**IEEE P802.15**  
**Wireless Personal Area Networks**

Project	IEEE P802.15 Working Group for Wireless Personal Area Networks (WPANs)	
Title	<b>Draft running comment resolution</b>	
Date Submitted	[9 July, 2004]	
Source	[James P. K. Gilb] [Appairant Technologies] [16990 Via Tazon, #125, San Diego, CA 92127]	Voice: [858-485-6401] Fax: [858-485-6406] E-mail: [last name at ieee dot org]
Re:	[]	
Abstract	[This document is a record of comment resolutions and proposals for draft development of 802.15.3b.]	
Purpose	[To provide a record of the comment resolution and proposals for draft development of 802.15.3b.]	
Notice	This document has been prepared to assist the IEEE P802.15. It is offered as a basis for discussion and is not binding on the contributing individual(s) or organization(s). The material in this document is subject to change in form and content after further study. The contributor(s) reserve(s) the right to add, amend or withdraw material contained herein.

Figure 5—Message sequence chart for relinquishing CTA time when the destination DEV has data to send.

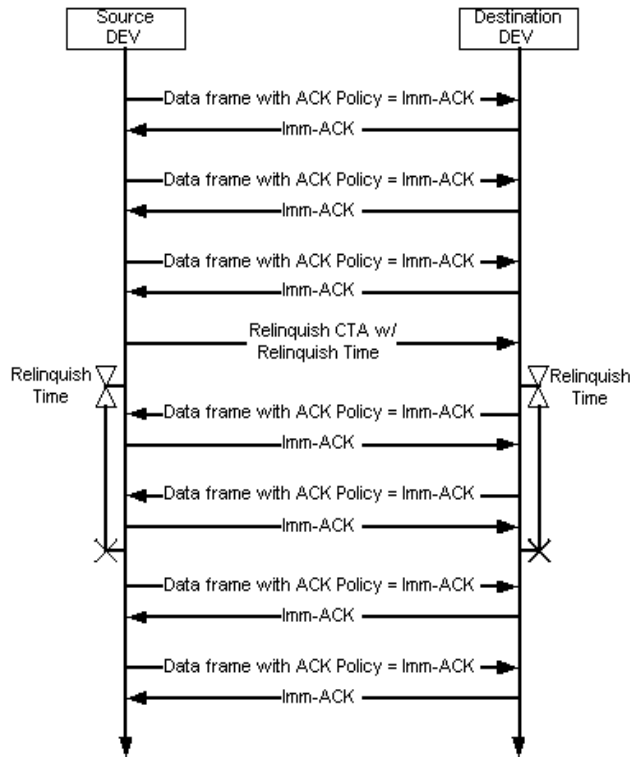
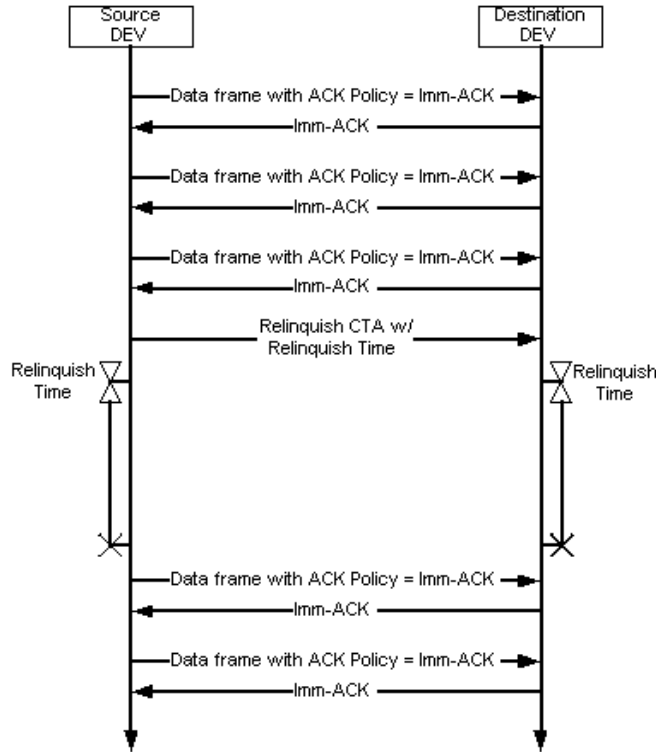
If the destination DEV has data that it needs to send, it may use the time provided by the source DEV to send data frames, as illustrated in Figure 5. The destination DEV that has transmit control in a CTA is not required to use it only for communication with the source DEV. It may send frames to any device in the piconet, but it should only send frames if it determines that the destination of its frames will be listening during that time.
